# **802.3ar Frame Expansion**

***Proposed changes to Clause 3***

**Kevin Daines**

**13 July 2004**

# Figure 3-1

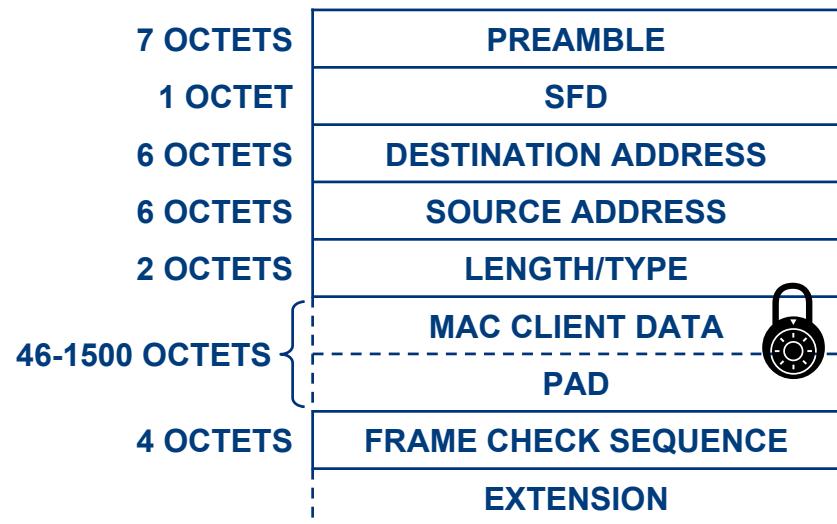
IEEE 802.3-2002/Figure 3-1  
MAC frame format

IEEE 802.3ar/Figure 3-1  
MAC frame format

# Figure 3-3

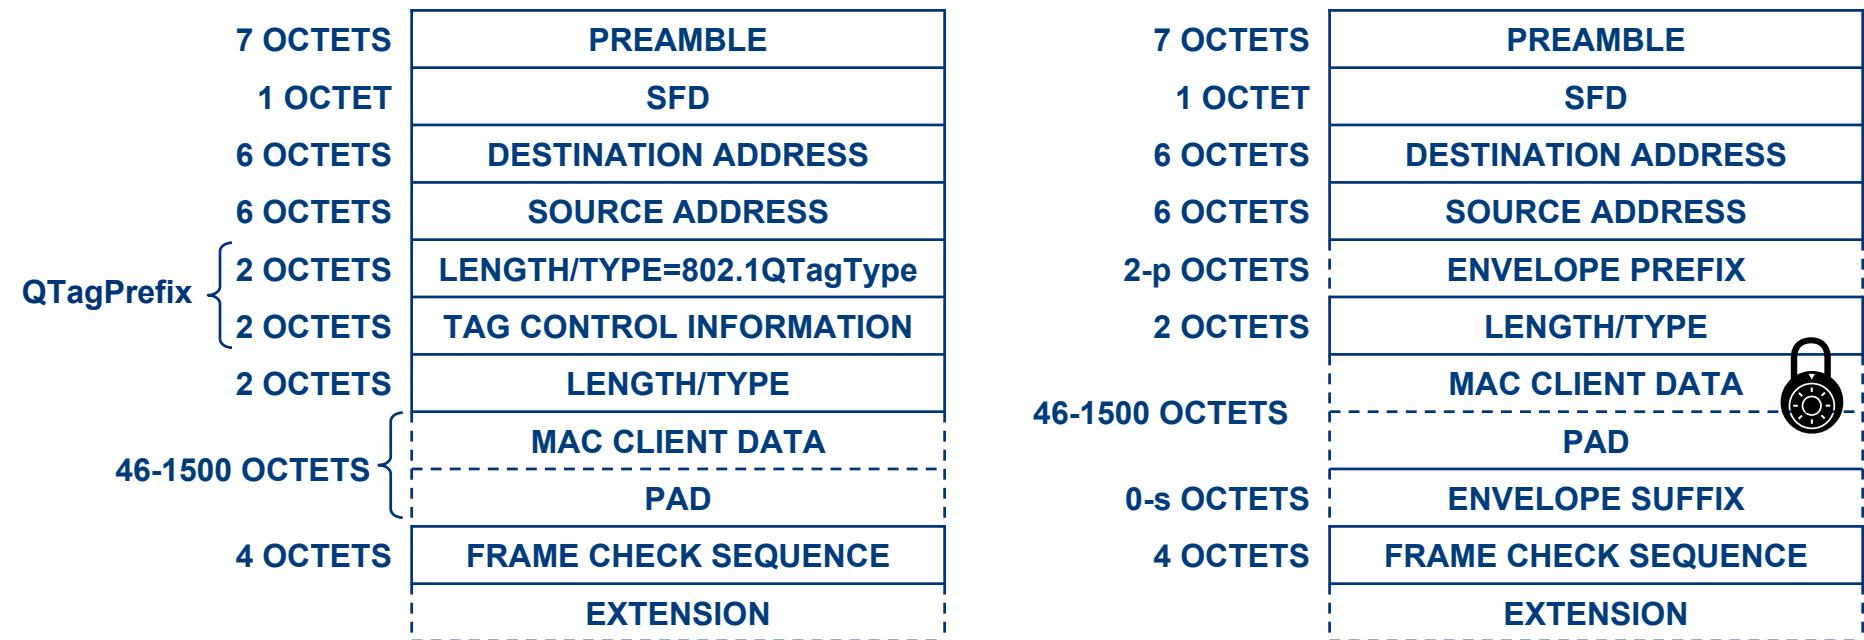
IEEE 802.3-2002/Figure 3-3  
Tagged MAC frame format

IEEE 802.3ar/Figure 3-3  
*Envelope* MAC frame format

p is 2 to max[2, **TBD – suffixSize**]

s is 0 to max[0, **TBD – prefixSize**]

# Frame sizes

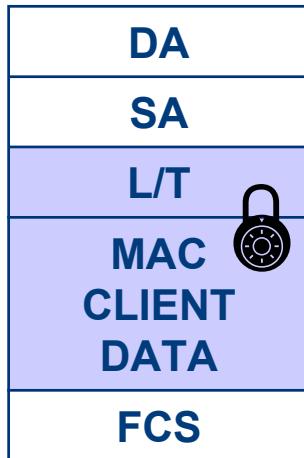
Frame Sizes	802.3-2002	802.3ar
Minimum basic MAC frame size	64 octets	64 octets
Maximum basic MAC frame size	1518 octets	1518 octets
Minimum Tagged MAC frame size	64 octets	N/A
Maximum Tagged MAC frame size	1522 octets	N/A
Minimum <i>Envelope</i> MAC frame size	N/A	68 octets
Maximum <i>Envelope</i> MAC frame size	N/A	TBD octets
